Rezoning Application: PD 25-0469

Development Services Department

AGENCY REVIEW COMMENT SHEET

8.0 PROPOSED SITE PLAN (FULL)

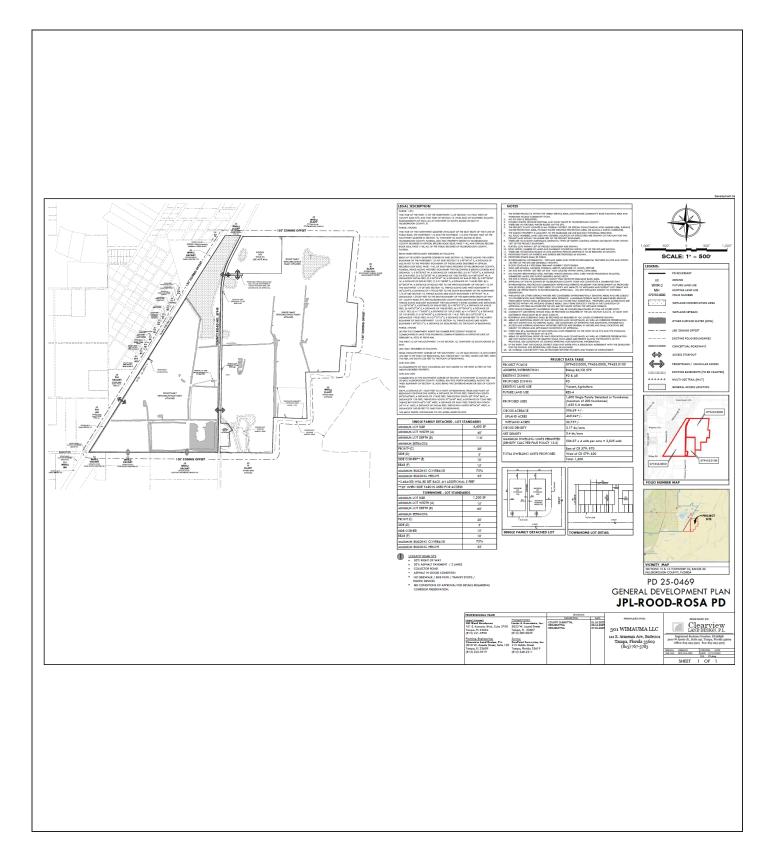
- 1. Correct the symbology for the southernmost stubout along the western PD boundary (staff notes it should use the access stubout symbology rather than the pedestrian/vehicular access symbology) and label as "Proposed Southernmost Roadway Stubout See Conditions of Approval".

- 2. Correct the symbology for the northernmost stubout along the western PD boundary (staff notes it should use the access stubout symbology rather than the undefined symbology used) and correct the label to instead read "Proposed Northernmost Roadway Stubout See Conditions of Approval".

- 4. Add labels at both project intersections on CR 579 and label as "Potential Signal/Roundabout/Other Improvement See Condition of Approval".
- 5. Add labels/depict the approximate location of "Lesser Goldfinch Dr." and "Redpoll Cliff Place" (reference Westlake Phase 2, Plat Book 148 Page 159 for additional information).

- 6. Label the unimproved right-of-way "F St." (reference Plat of Halifax inset within the Revised Map of Town of Wimauma, Plat Book 1, Page 136).
- 7. Revise Note 13 to instead state "Roadways within the Western Development Area shall be public. Roadways within the Eastern Development Area may be public or private. Roadways that are proposed to be maintained by Hillsborough County shall demonstrate consistency with Policy 4.1.4 of the Mobility Element of the Hillsborough County Comprehensive Plan."

- 8. Revise Note 21 to replace the words "Access and" with the words "Except as otherwise specified in the zoning conditions."
- Revise Note 25 to delete the duplicated "25."

--Northern Boundary--

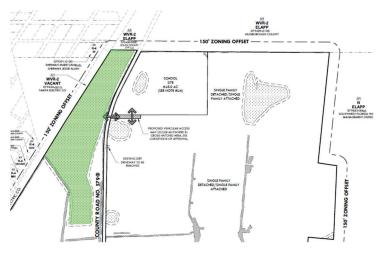
The northern property boundary within the Western Development Area is approximately 400 feet in length (between the TECO corridor and CR 579). Given the connection spacing standards, zero connections are required. While applicant is proposing zero connections; however, CR 579 provides north-south connectivity and bifurcates the PD. The entirety of the northern portion of the site within the Western Development Area is shown as wetland/conservation areas. These areas have been shown in green.

--Southern Boundary--

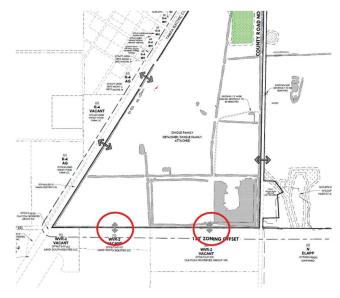
The southern property boundary is approximately 3,200 feet in length (between the TECO corridor and CR 579). Given the connection spacing standards, a total of two connections would be required (rounded down from 2.42). In addition to the CR 579 north-south corridor, the developer is providing two additional connections (for a total of three connections provided). Applicant-proposed through road connections are shown circled in red.

not there is a roadway currently planned to connect to the stubout). This offset roadway design also has the effect of calming through road traffic, and is consistent with LDC Section 6.02.01.A.10 which states "Local streets should be designed to discourage excessive speeds. Residential streets should be designed to discourage fast movement (more than 30 MPH), through the use of curvilinear alignment and by offsetting local street intersections." Internal project design will be reviewed for compliance with this and other applicable standards at the time of site/construction plan review. Notwithstanding the above, staff has prepared a graphic showing approved projects, planned and under construction corridors, together with other possible corridors to conceptually demonstrate how connectivity is planned and can potentially be enhanced to meet community goals. Staff notes that such connectivity not only increases bicycle and pedestrian safety and provides alternate routes to schools and for emergency vehicles, but it also provides important redundancy in our roadway systems, which can become critical alternative routes during accidents, other emergencies, and to maintain the safe/functional operations of our roadways and intersections as area roadways exceed planned capacities.

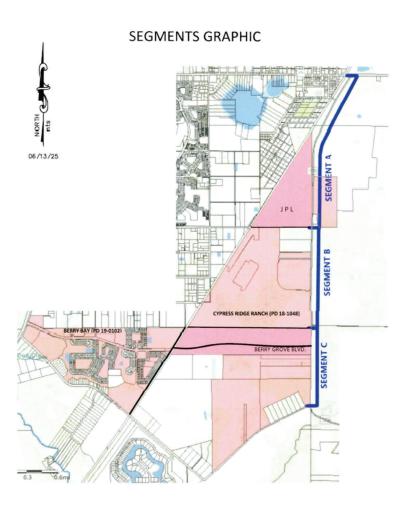
- Improvements were split into three segments. Segment A is defined as that portion of CR 579 between SR 674 and the southern boundary of the PD. Segment B is defined as that portion of CR 579 between the southern boundary of the subject PD and the southern boundary of the adjacent Cypress Ridge Ranch project (i.e. adjacent PD 24-1033). Segment C is defined as that portion of CR 579 between the southern boundary of the adjacent Cypress Ridge Ranch project (i.e. adjacent PD 24-1033) and Saffold Rd. A graphic has been provided below to demonstrate these areas.
- The developer shall be permitted to utilize the existing 10-foot to 11-foot-wide travel lanes in their existing configuration in lieu of the 12-foot-wide travel lanes required by the Hillsborough County Transportation Technical Manual's (TTM) TS-7 Typical Section; and,

- In lieu of the 8-foot-wide shoulders (of which 5 feet is paved) typically required by the TTM's TS-7, the developer will be permitted to construct 6-foot-wide stabilized shoulders (of which 5-feet is paved) within Sections A and B, and 5-foot-wide paved shoulders within a stabilized shoulder of indeterminate width within Segment C.
- In lieu of 7-foot-wide buffered bicycle facilities along both sides of the roadway, the developer will be permitted to install a 10-foot-wide multi-use path within Segment A along the west side of CR 579 (transitioning to a 5-foot-wide sidewalk north of the project where necessary due to right-of-way constraints).

If 25-0469 is approved by the BOCC, the County Engineer will approve the Design Exception request.
